# A47 North Tuddenham to Easton Dualling

## **9.15 Alternative Wood Lane Junction Options Appraisal**

**ALTERNATIVE WOOD LANE JUNCTION OPTIONS APPRAISAL**

<b>RegulationRule Number:</b>	Rule 8(1)(c)
<b>Planning Inspectorate Scheme Reference</b>	TR010038
<b>Application Document Reference</b>	TR010038/EXAM/9.15
<b>BIM Document Reference</b>	HE551489-GTY- <del>HGNLSI</del> -000-RP- <del>CH-30012</del> <u>TX-40013</u>
<b>Author:</b>	A47 North Tuddenham to Easton Project Team, Highways England

[Figure 2-2: Wood Lane Junction Alternative 1](#)

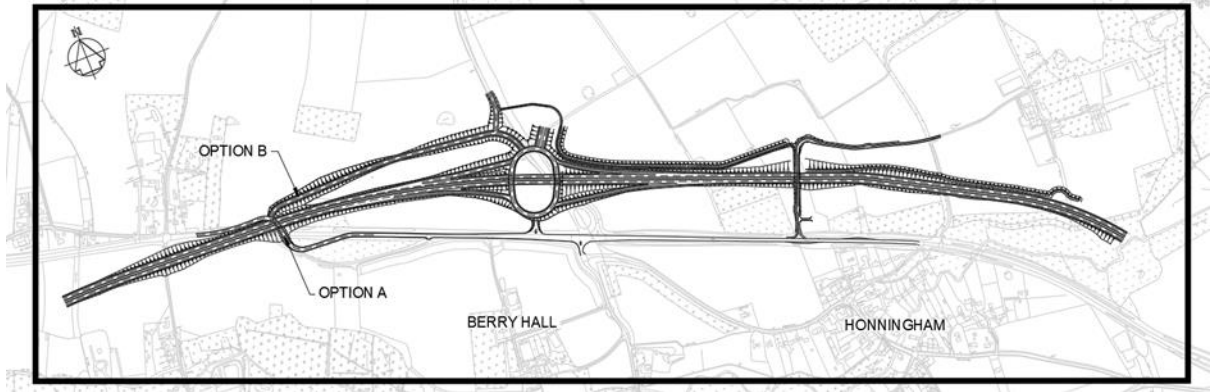
3.2.4 The mainline horizontal geometry shown is generally above the desirable minimum radius for a 120kph design speed and therefore complies with the required standards.

- 3.2.5 The exception to this is the 990m horizontal radius used at the eastern tie-in to the developed design. This falls one step below desirable minimum horizontal radius of 1,020m required of a 120kph design speed road and is therefore a horizontal relaxation.

- 3.2.6 As this relaxation occurs in advance of the junction diverge slip, widening to provide full stopping sight distance would be necessary to avoid this being classified as a “Departure from the standard” (CD 109, Clause 2.13).

- 3.2.7 This has not been accounted for in the alternative design and would increase permanent land take accordingly.
- 3.2.8 ~~It is also worth noting that~~ The new mainline alignment would be closer to residential properties at Hall Farm, thus increasing likely noise impacts for properties already predicted to experience a significant adverse residual noise effect during operation of the Scheme design; see Environmental Statement Chapter 11 Noise and Vibration (**APP-150**).

- 3.2.9 Option A, with Lady’s Grove underpass, would also bring the proposed existing A47 side road closer to Hillcrest Cottage compared to the Scheme design.

Figure 2-4: Wood Lane Junction Alternative 2

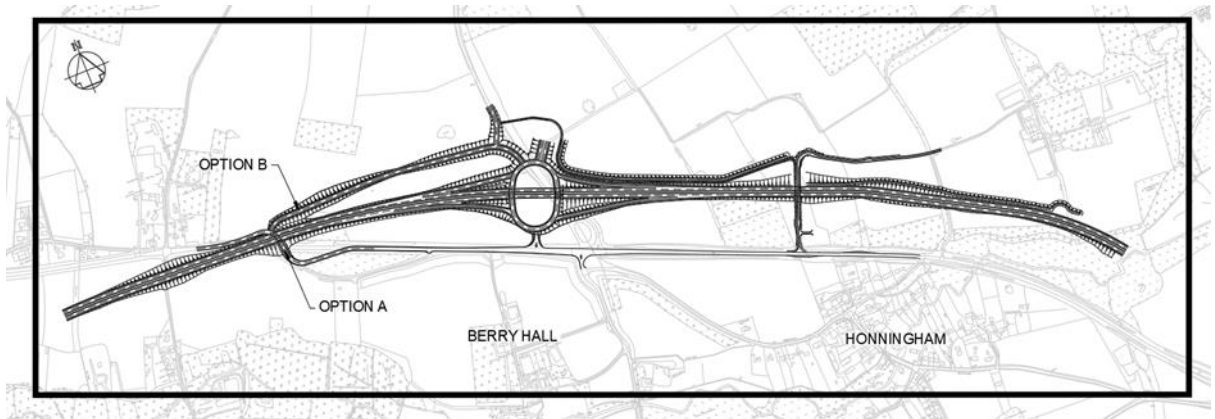
- 3.2.10 The mainline horizontal geometry shown falls below the desirable minimum radius for a 120kph design speed in two locations:-
- A 720m horizontal radius is used east of the farm access underpass.

- A 720m horizontal radius is used at the eastern tie-in to the developed design.
- 3.2.11 Both these fall one step below desirable minimum horizontal radius of 1,020m required of a 120kph design speed road and are therefore horizontal relaxations.

- 3.2.12 As these relaxations occur in advance of the junction diverge slip, widening to provide full stopping sight distance would be necessary in order to avoid this being classified as a departure from the standard (CD 109, 2.13).

- 3.2.13 This has not been accounted for in the alternative design and would increase permanent land take accordingly.
- 3.2.14 Option A, with Lady’s Grove underpass, would also bring the proposed existing A47 side road closer to Hillcrest Cottage compared to the Scheme design.

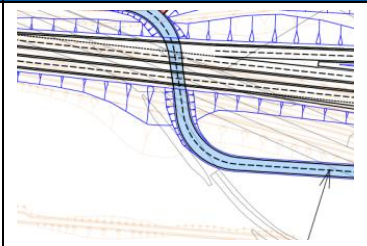
A-3	Westbound approach to proposed Lady's Grove underpass.	Loss of control	<p>The alignment features a tight right-hand bend which will likely be on a downhill gradient, preceded by a slight left-hand bend which would mask the tighter bend, located at the end of a long straight.</p> <p>It is likely that speeds will be high on the approach, and the left bend may be safely negotiated at speed. This may result in the high speed being carried into the second bend, which is exacerbated by the downhill gradient.</p> <p>This increases the risk of loss of control collisions for vehicles attempting to negotiate the right-hand bend.</p>	
A-4	Eastbound approach to proposed Lady's Grove underpass	Loss of control	<p>The alignment features a tight right-hand bend which will likely be on a downhill gradient, located at the end of a long straight.</p> <p>It is likely that speeds will be high on the approach which is exacerbated by the downhill gradient increasing a vehicles momentum</p> <p>This increases the risk of loss of control collisions for vehicles attempting to negotiate the right-hand bend.</p>
